# UNITED STATES PATENT AND TRADEMARK OFFICE

APPLICATION NO.	FILING DATE	FIRST NAMED INVENTOR	ATTORNEY DOCKET NO.	CONFIRMATION NO.
10/575,352	01/31/2008	Richard E. Smalley	11321-P077WOUS	9439
47744	7590	12/13/2010	EXAMINER	
WINSTEAD PC			MCCRACKEN, DANIEL	
WINSTEAD PC				
P. O. BOX 50784			ART UNIT	
DALLAS, TX 75201			PAPER NUMBER	
			1736	
			MAIL DATE	
			DELIVERY MODE	
			12/13/2010	
			PAPER

<b>Office Action Summary</b>	<b>Application No.</b> 10/575,352	<b>Applicant(s)</b> SMALLEY ET AL.	
	<b>Examiner</b> DANIEL C. MCCracken	<b>Art Unit</b> 1793

**I. Figure 6 is objected to.**

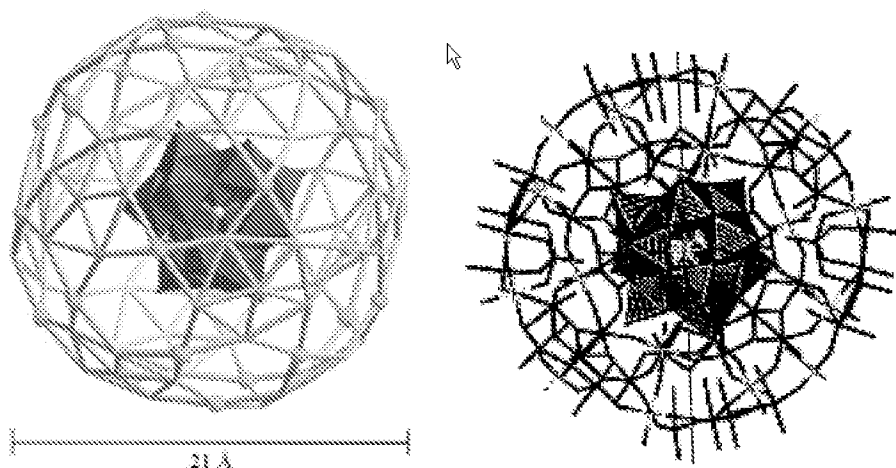
Figure 6 should be designated by a legend such as --Prior Art-- because only that which is old is illustrated. See MPEP § 608.02(g). Figure 6 appears to be copied from Figure 1 of Muller, et al., *A New Type of Supramolecular Compound: Molybdenum-Oxide-Based Composites Consisting of Magnetic Nanocapsules with Encapsulated Keggin-Ion Electron Reservoirs Cross-Linked to a Two-Dimensional Network*, *Angew. Chem.* 2000; 122(19):1555-1559. Figure 1 of Muller is reproduced below on the left next to Figure 6 of the instant application on the right.

To the extent any of the other figures are in fact from other publications, the Examiner requests this be made of record and the figures designated "Prior Art," accordingly.

Corrected drawings in compliance with 37 CFR 1.121(d) are required in reply to the Office action to avoid abandonment of the application. The replacement sheet(s) should be labeled "Replacement Sheet" in the page header (as per 37 CFR 1.84(c)) so as not to obstruct any portion of the drawing figures. If the changes are not accepted by the examiner, the applicant will be notified and informed of any required corrective action in the next Office action. The objection to the drawings will not be held in abeyance.
